HANFORD FEDERAL FACILITY AGREEMENT AND CONSENT ORDER CHANGE CONTROL FORM:  
REDESIGNATION OF THE 200-ZP-1 AND 200-ZP-2 OPERABLE UNITS (OUs) AND  
REDEFINITION OF THE 200 WEST AREA GROUNDWATER OUs

Change Number <b>C-93-04</b>	<b>Federal Facility Agreement and Consent Order          Change Control Form</b> Do not use blue ink. Type or print using black ink.	Date <b>3/21/1993</b>
---------------------------------	---	--------------------------

Change Title <b>REDEFINITION OF THE 200-ZP-1 GROUNDWATER OPERABLE UNIT AND REASSIGNMENT OF ASSOCIATED GROUNDWATER INVESTIGATIONS, WASTE MANAGEMENT UNITS, AND UNPLANNED RELEASES.</b>
--

Water Table Map with Recommended Groundwater Operable Units for the 200 West Area

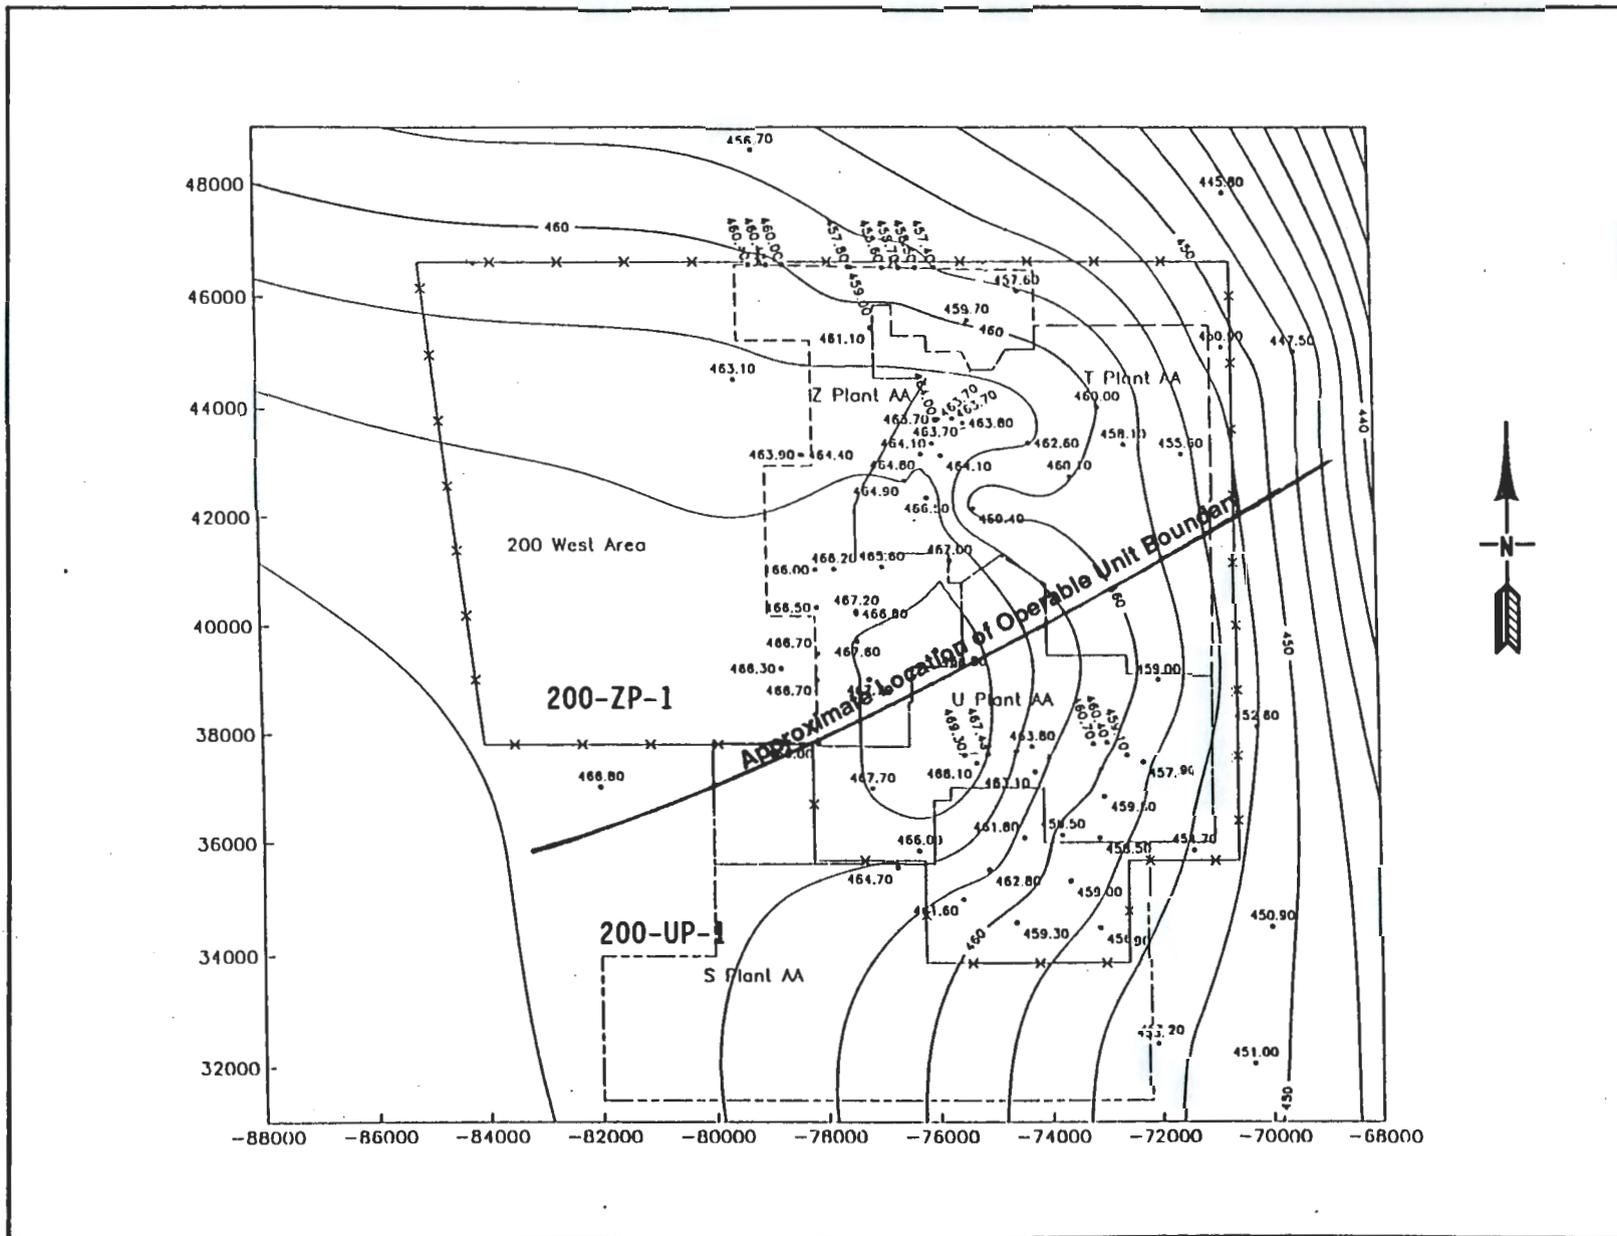
These two groundwater operable units would be divided on the basis of the hydrologic flow system present under the aggregate area. Two parallel hydrologic regimes can be defined, both emanating from the groundwater mound found beneath the location of the former U Pond (216-U-10). Groundwater flow on the north and northeast sides of the mound generally flows north-northeast towards Gable Gap. Groundwater south and east of the mound generally flows east-southeast towards a point south of the 200 East Area. The distributions of the contaminant plumes in the 200 West Groundwater Aggregate Area reflect these flow conditions. Contaminant plumes in the one regime or the other generally do not mix. These two groundwater flow regimes can therefore be the basis of the two groundwater operable units. The line of their division runs approximately along the northern edge of the U Plant Source Aggregate Area (see attached figure), as derived from groundwater potentiometric maps and the extent of the various known plumes.

Because of the interrelations of the contaminant plumes in the 200 West Area, it is considered best to have a relatively small number of groundwater operable units. It is also important, however, to keep the size and complexity of groundwater operable units small enough so that each can handle all groundwater issues in that portion of the 200 West Area. It is believed that these considerations can best be addressed by redefining operable units to create two groundwater operable units.

1. All waste management units and unplanned releases listed under 200-ZP-1 shall be moved to 200-ZP-2, and 200-ZP-2 designated as unit category CPP.
2. Redesignate the 200-ZP-1 Operable Unit as a groundwater only operable unit which will address the groundwater beneath the 200-ZP-2, 200-TP-2, and 200-TP-4 Operable Units. 200-ZP-1 should be designated as unit category CPP and given a priority of A.
